UNITED STATES PATENT AND TRADEMARK OFFICE

APPLICATION NO.	FILING DATE	FIRST NAMED INVENTOR	ATTORNEY DOCKET NO.	CONFIRMATION NO.
10/771,289	02/05/2004	Cyril Meziere	07552.0022	2868
22852	7590	11/07/2008		
FINNEGAN, HENDERSON, FARABOW, GARRETT & DUNNER LLP 901 NEW YORK AVENUE, NW WASHINGTON, DC 20001-4413				
EXAMINER				
DEAK, LESLIE R				
ART UNIT		PAPER NUMBER		
3761				
MAIL DATE		DELIVERY MODE		
11/07/2008		PAPER

Office Action Summary

DETAILED ACTION

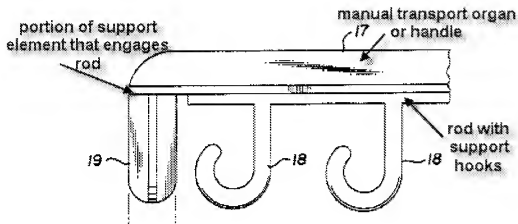
With regard to claims 8-13, 24, the support elements comprise a body or rod that carries a top section that may be used as a manual transport organ or handle to rotate the support elements or arms. The body or rod further comprises hooks 18 and is connected to the support element. See Belokin FIG2, as annotated by the Examiner, below.
